Wisconsin Department of Transportation

Proposal #12: 1228-16-71, WISC 2018 142
North South Freeway
Green Tree Rd Bridge B-40-0149
IH 043
Milwaukee County

This is Addendum No. 01, which provides for the following:

Addendum No. 01
 ID 1228-16-71
 Revised Sheet 8
 March 6, 2018

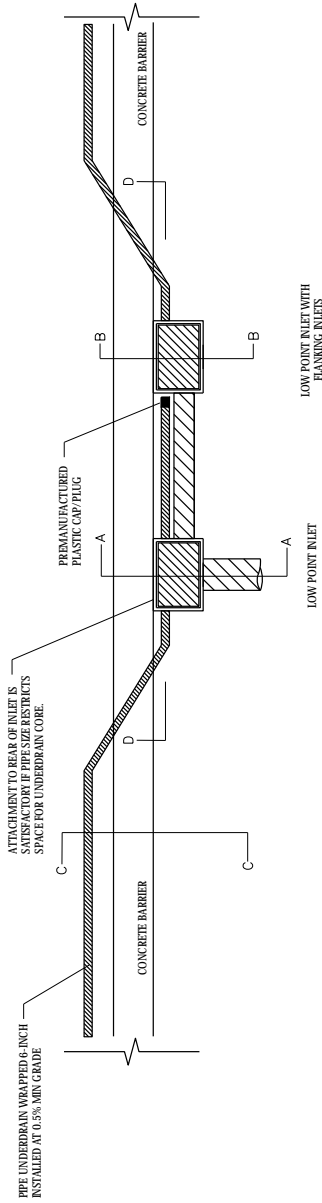
Revised Plan Sheets	
Plan Sheet	Plan Sheet Title (brief description of changes to sheet)
08	Typical Section: NB 43 inside shoulder width
09	Construction Details: Added note regarding the underdrain inlet cores
10	Construction Details: Added detail for storm pipe crossing NB 43
17	Removals: NB 43 inside shoulder removal limits
19	Removals: NB 43 inside shoulder removal limits
28	Plan Details: NB 43 inside shoulder width, pavement material NB 43 pipe crossing
35	Paving Grades: NB 43 inside shoulder
36	Paving Grades: NB 43 inside shoulder
40	Curb Ramp Details: Fixing elevation error
41	Curb Ramp Details:
48	Erosion Control: Eliminated type A inlet protection in various locations
50	Erosion Control: Eliminated type A inlet protection in various locations
51	Erosion Control: Eliminated type A inlet protection in various locations
54	Erosion Control: Eliminated type A inlet protection in various locations
55	Erosion Control: Eliminated type A inlet protection in various locations

Addendum No. 01
 ID 1228-16-71
 Added Sheet 15B
 March 6, 2018

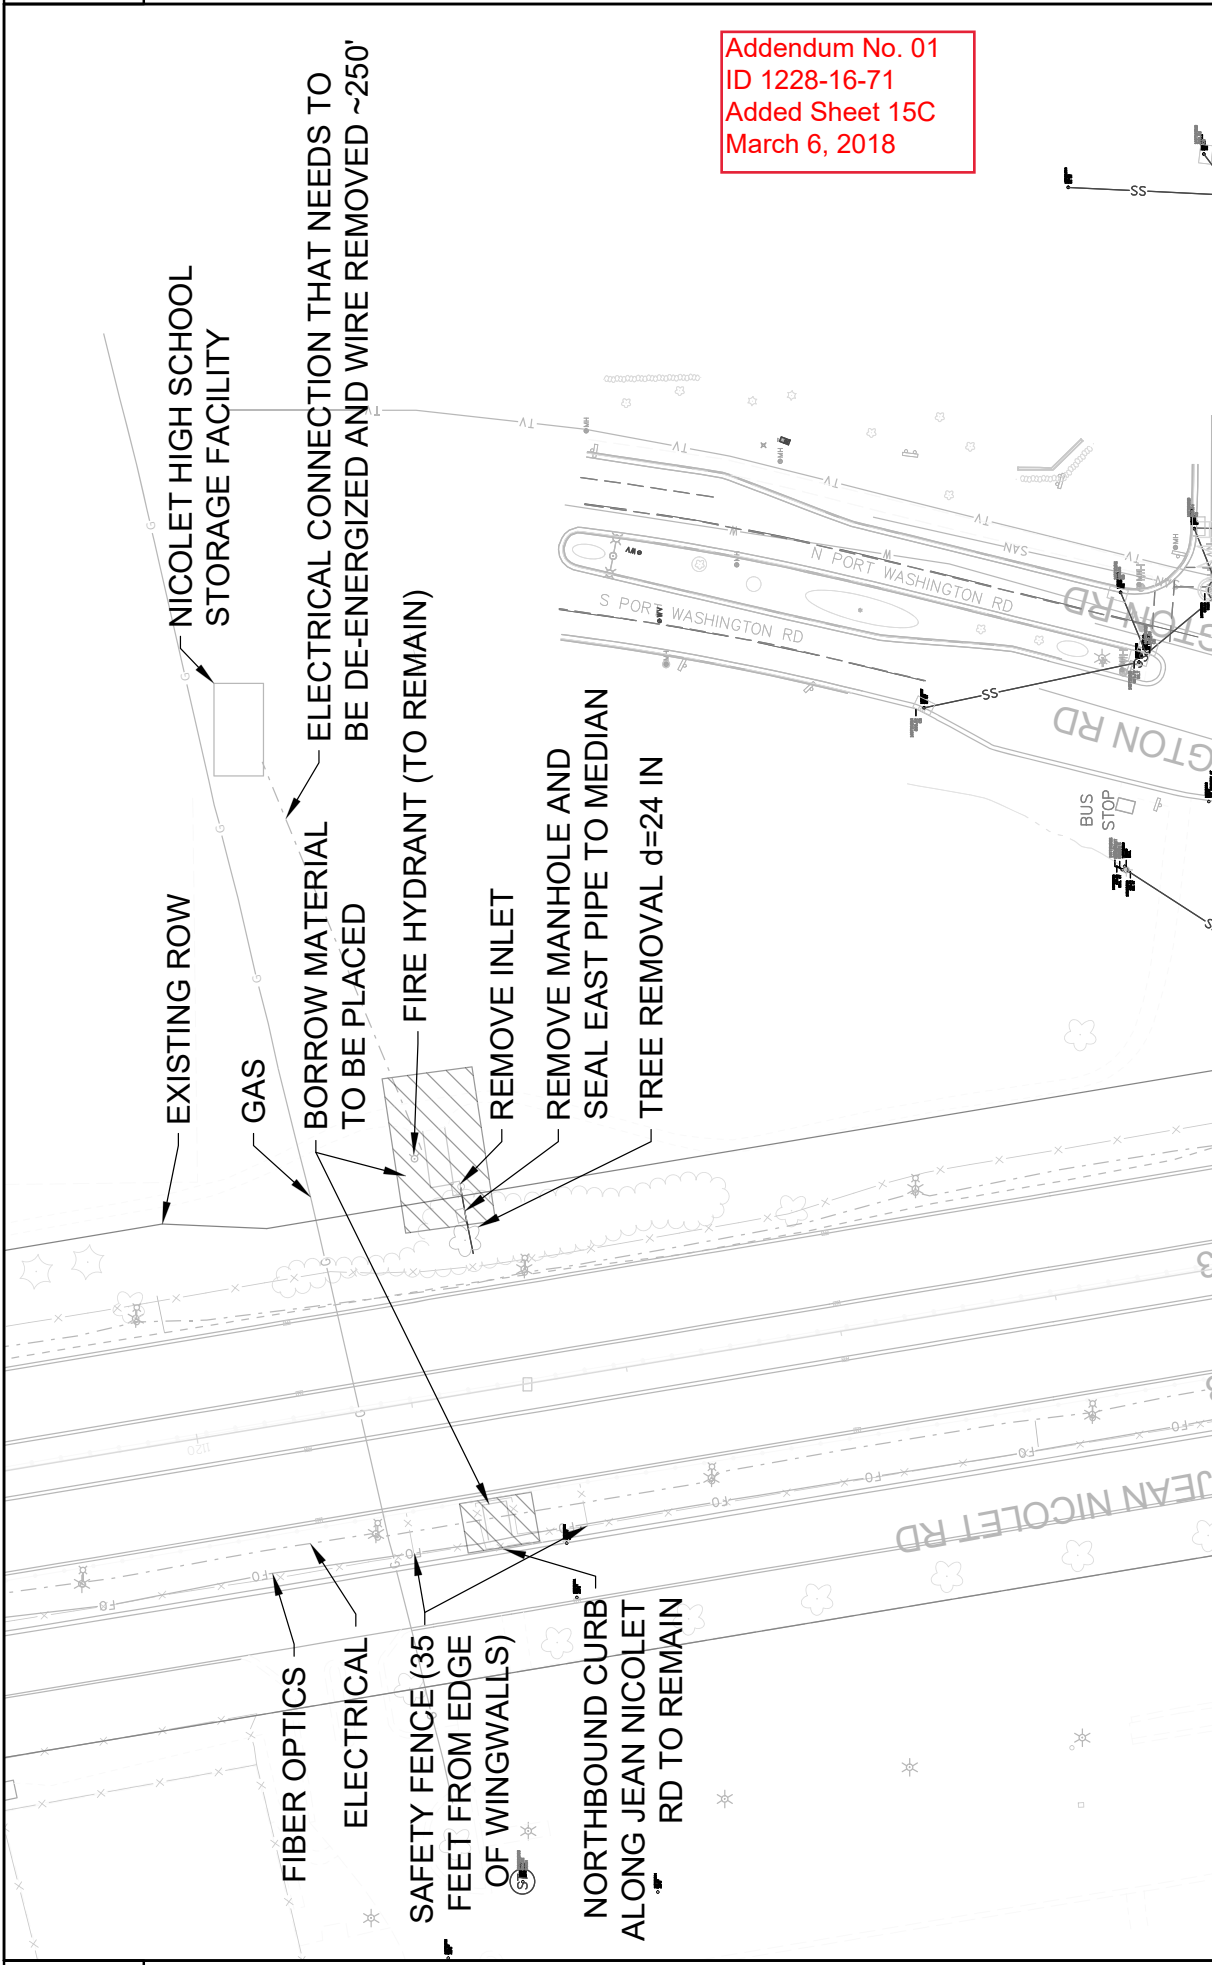
Added Plan Sheets	
Plan Sheet	Plan Sheet Title (brief description of why sheet was added)
15A	Construction Details: Abandon existing pedestrian culvert crossing
15B	Construction Details: Abandon existing pedestrian culvert crossing
15C	Construction Details: Abandon existing pedestrian culvert crossing
188A	Misc. Quantities: Added quantity tables for the pedestrian crossing abandonment

REMOVE EVERYTHING LEFT (WEST) OF THE SAW CUT

REMOVE EVERYTHING RIGHT (EAST) OF THE SAW CUT

NOTE: OVERLAP SHEET PILE 1' ON BOTH SIDES OF THE TUNNEL OPENING

Addendum No. 01
 ID 1228-16-71
 Revised Sheet 58
 March 6, 2018

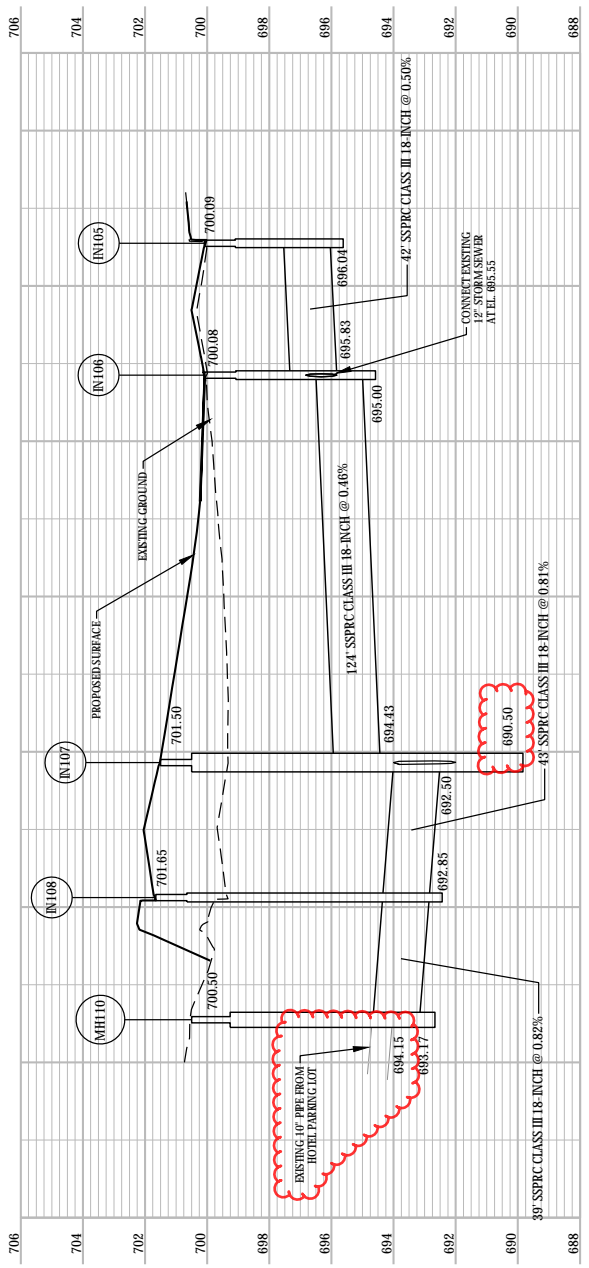
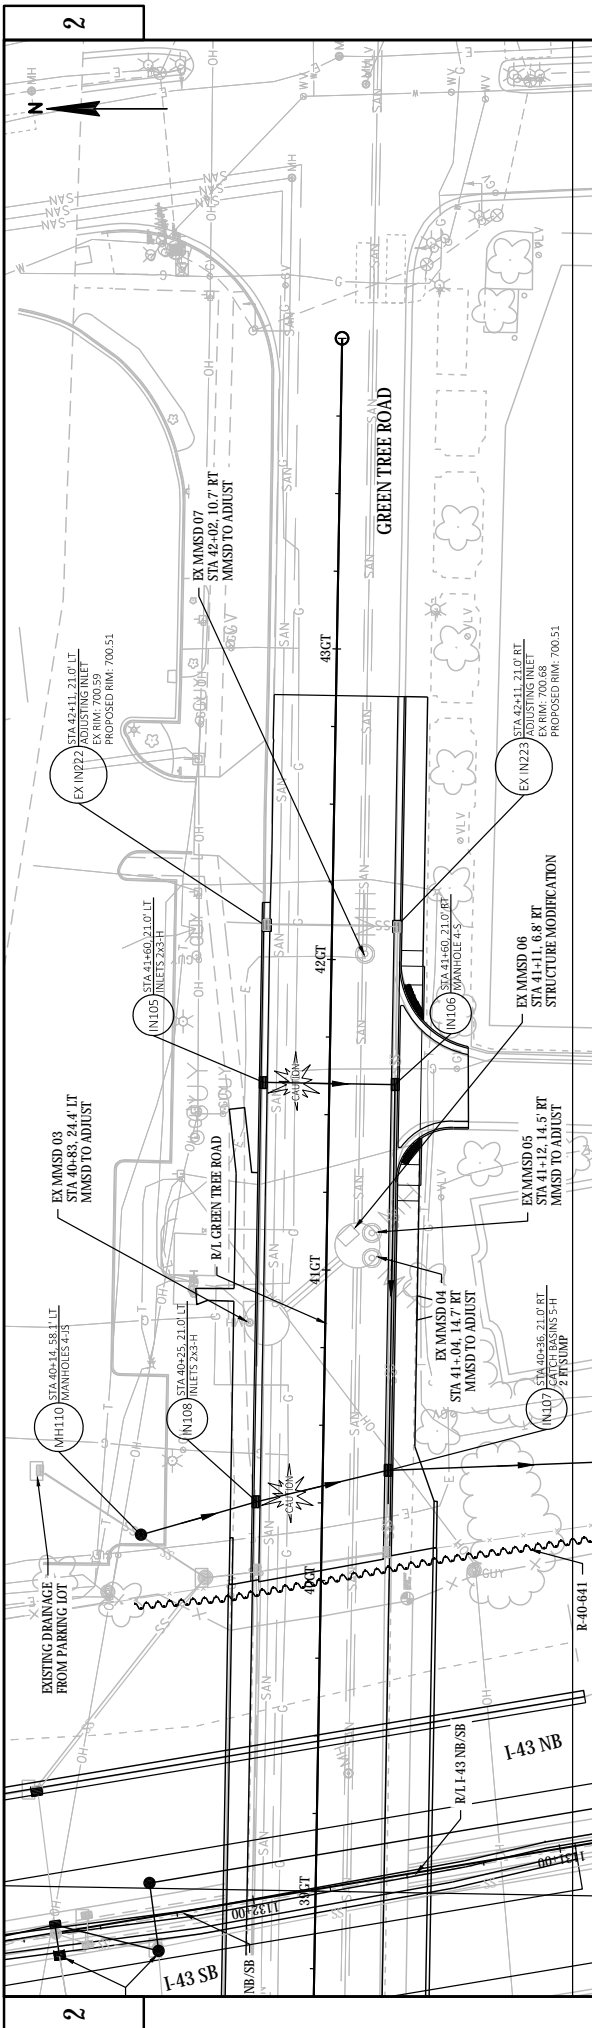
58	Storm Sewer: Various changes the plans and/or profiles
59	Storm Sewer: Various changes the plans and/or profiles
60	Storm Sewer: Various changes the plans and/or profiles
61	Storm Sewer: Various changes the plans and/or profiles
63	Storm Sewer: Various changes the plans and/or profiles
64	Storm Sewer: Various changes the plans and/or profiles
65	Storm Sewer: Various changes the plans and/or profiles
66	Storm Sewer: Various changes the plans and/or profiles
102	Traffic Control: Updated exhibit to reflect wider construction zone in the median shoulder
109	Traffic Control St1A: Traffic configuration shifted east to allow for more workzone near median
112	Traffic Control St1A: Details regarding the abandonment of the pedestrian crossing
114	Traffic Control St1A: Traffic configuration shifted east to allow for more workzone near median
115	Traffic Control St1A: Traffic configuration shifted east to allow for more workzone near median

Addendum No. 01
ID 1228-16-71
Revised Sheet 384
March 6, 2018

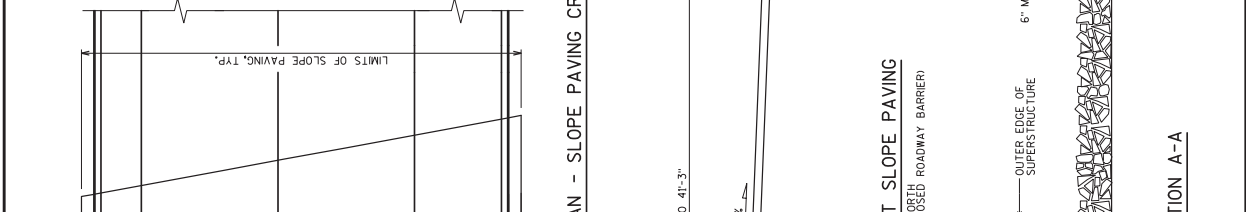
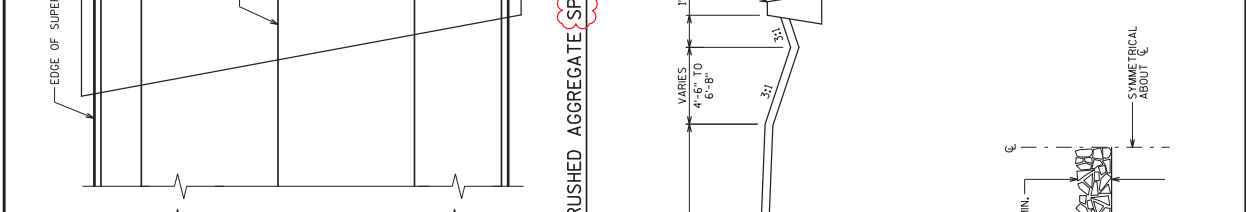
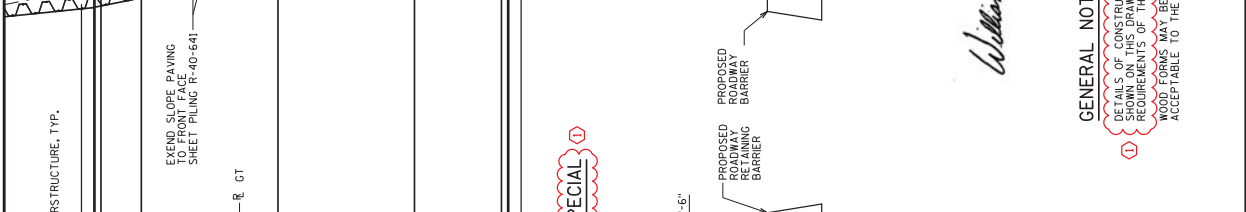
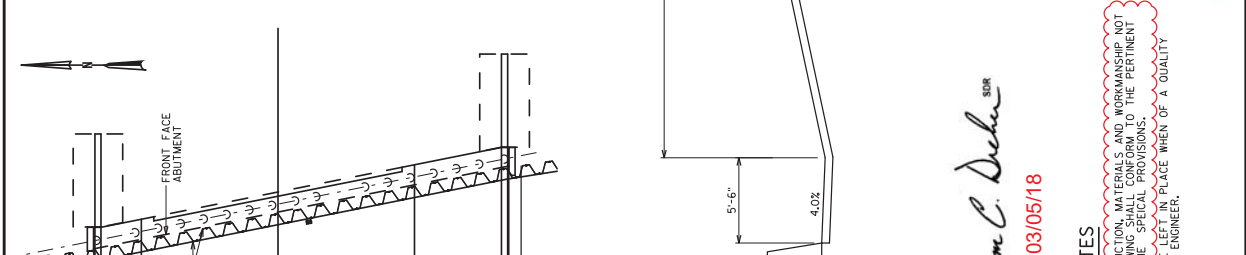
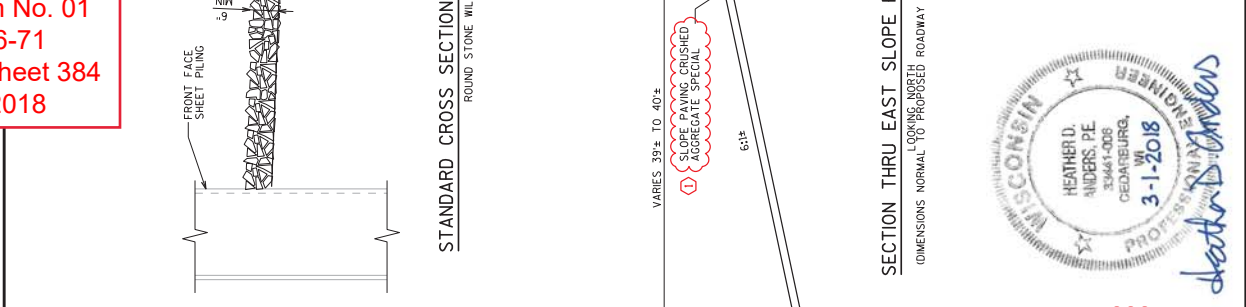
164	Misc Quantities: Removing sidewalk table added
165	Misc Quantities: Common excavation totals updated
166	Misc Quantities: Base aggregate dense totals updated
167	Misc Quantities: Concrete items added for the pipe crossing IH-43
168	Misc Quantities: Asphalt totals updated for the NB 43 inside shoulder
175	Misc Quantities: Inlet protection type A eliminated at various locations
178	Misc Quantities: Column added for drain slotted vanes
181	Misc Quantities: Vibration monitoring added
183	Misc Quantities: Storm sewer structures, various updates
184	Misc Quantities: Storm sewer structures, various updates
185	Misc Quantities: Storm sewer structures, various updates
186	Misc Quantities: Storm sewer structures, various updates
187	Misc Quantities: Storm sewer pipes, pipe slope updates
355	Structure Plans: Change to epoxy slope paving
357	Structure Plans: Change to epoxy slope paving
384	Structure Plans: Change to epoxy slope paving

STATE PROJECT NUMBER 1228-16-71	
NO.	DATE
1	3/1/18
ADDENDUM 1	SLOPE PAVING TYPE
HDA	HDA
REVISION	BY
STATE OF WISCONSIN DEPARTMENT OF TRANSPORTATION	
STRUCTURE B-40-917	
PLAN	MSS
DATE	PKGS.
3-1-2018	30
SLOPE PAVING CRUSHED AGGREGATE SPECIAL	
SHEET 30 OF 30 384

Addendum No. 01
 ID 1228-16-71
 Revised Sheet 408
 March 6, 2018

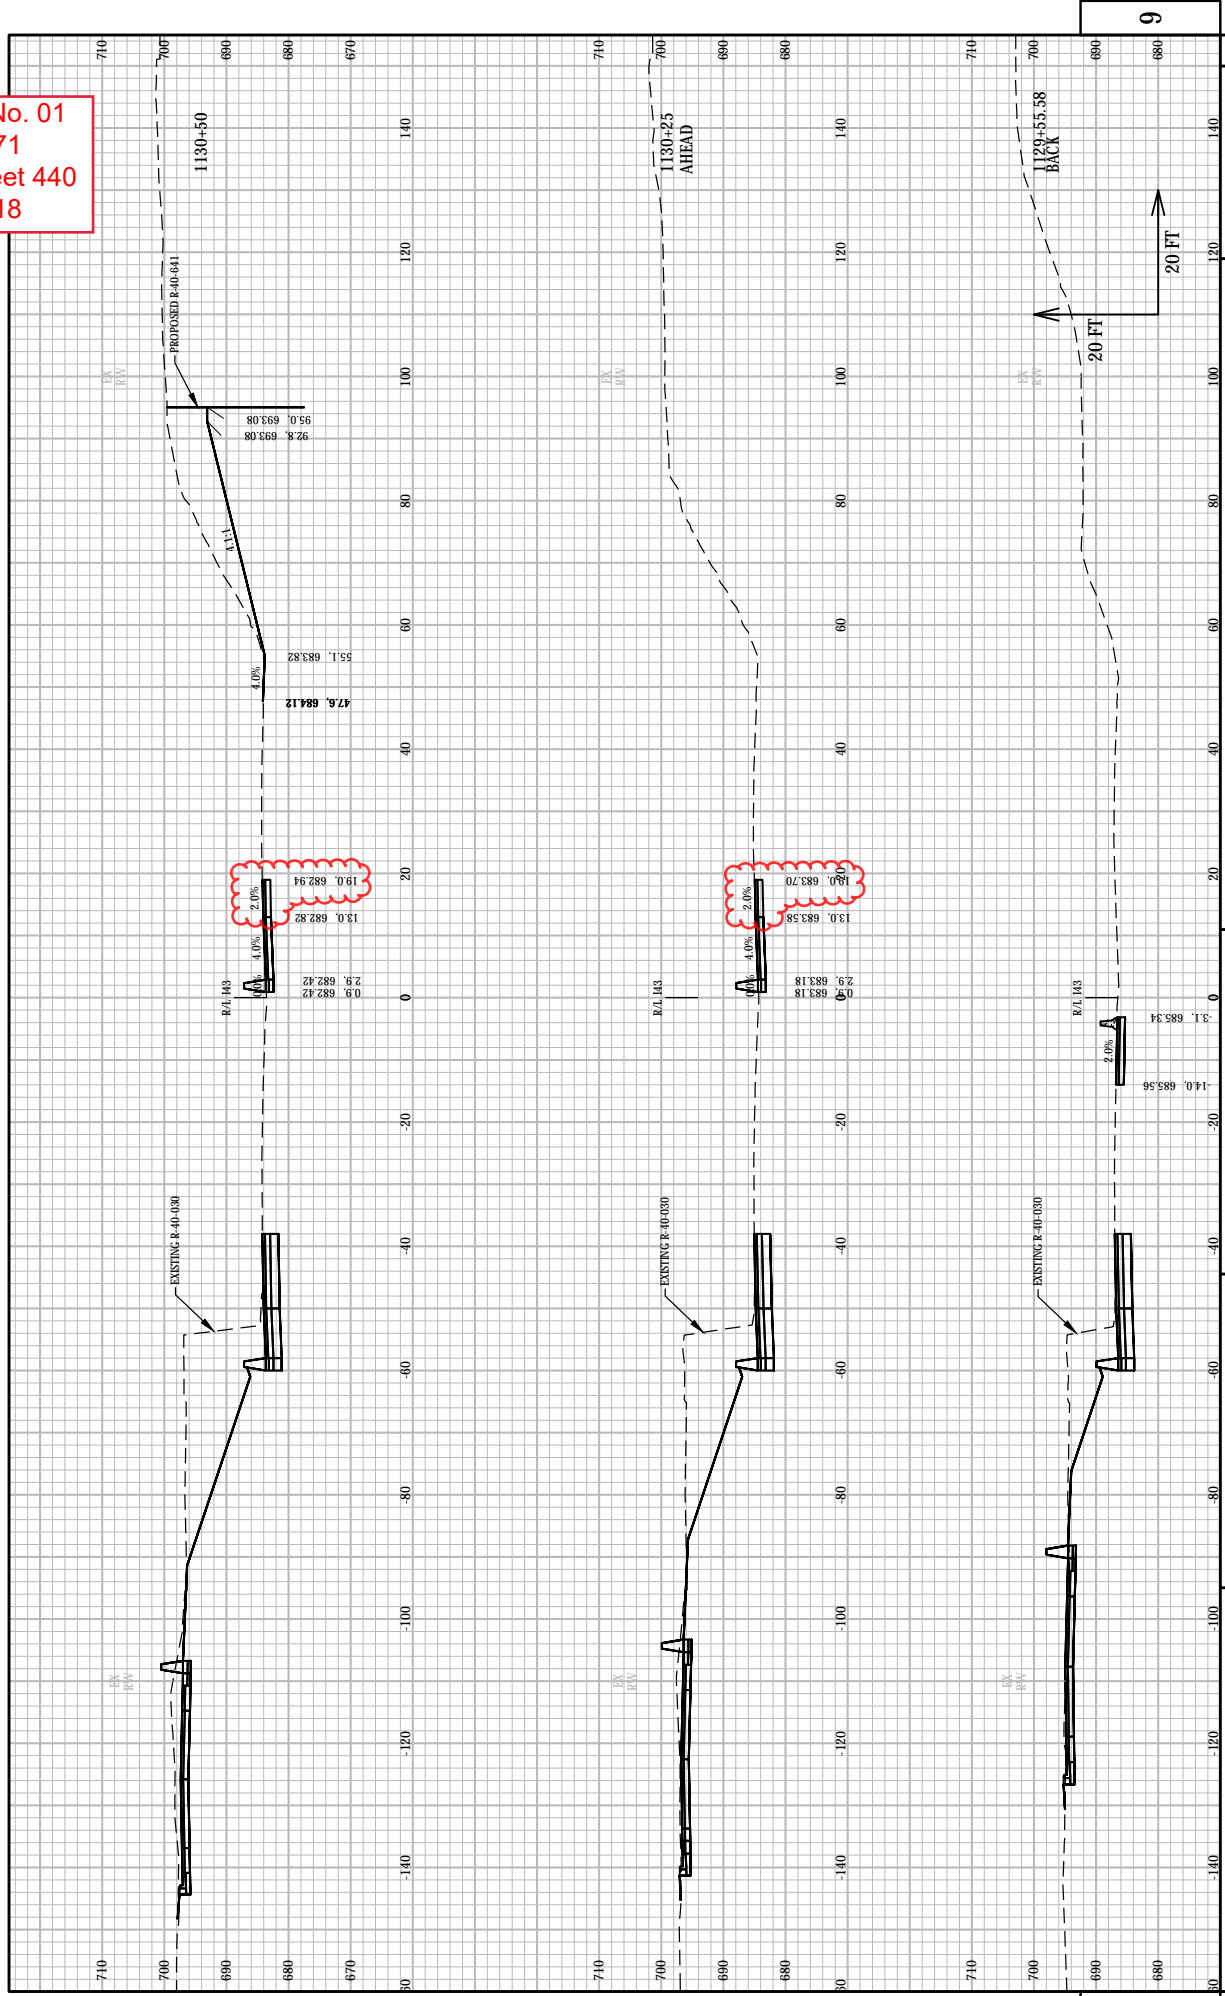
408	Earthwork Tables: Update to I-43 NB median shoulder, additional cut
440	Cross Sections – IH43: Update to the I-43 NB median shoulder
